Commercial Corridor Design Review Board

Clements Ferry Road @ I-526

Final Review for New Construction of a Multi-Family Development

PROJECT:
THE ALEXANDER
AT DANIEL ISLAND
CITY OF CHARLESTON, S.C.

A-2.1.1

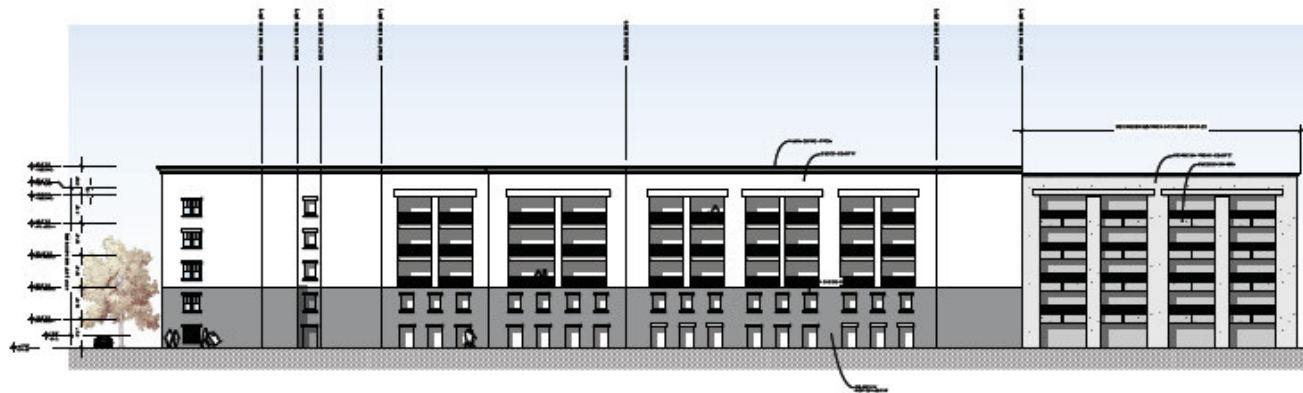
1 Comment: Restudy the fenestration of top floor.
Response: Top floor of west building modified to resemble penthouses and differentiate itself from adjacent buildings. See also A-2.1 and A-2.1.2

A-2.1

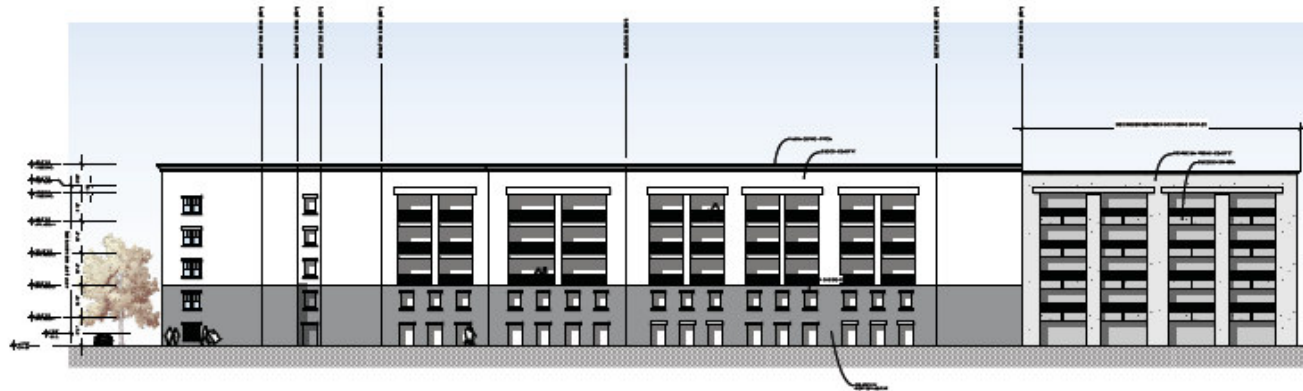
- 2** Comment: Simplify the building design by eliminating roof pediments.
Response: Roof pediments have been eliminated to simplify the design.
- 3** Comment: Simplify the color palette by eliminating the accent color on the window sills.
Response: Linoleum above windows, doors, and balconies now match the adjacent field colors.
- 6** Comment: Provide exterior murals on all divided window fls.
Response: All divided window fls will have exterior murals.
- 7** Comment: Provide additional screening for the exposed garage elevations.
Response: Fig Ivy is added to the exposed garage facades as well as brick and paint to screen the garage elevations.

- 1** Comment: Restudy garage elevations.
Response: The Type 2 street and Highway Garage elevations are revised. Brick, paint, and expanded railing (similar to the apartment balconies) are added to the facades to relate the garage back to the apartment buildings. A trellis with Fig Ivy is added at the garage entry elevation and Fig Ivy is used on both the Type 2 street and Highway elevations to screen view of the garage.
- 2** Comment: Differentiate top floor of west building.
Response: Top floor of west building modified to resemble penthouse and differentiate level from adjacent buildings.
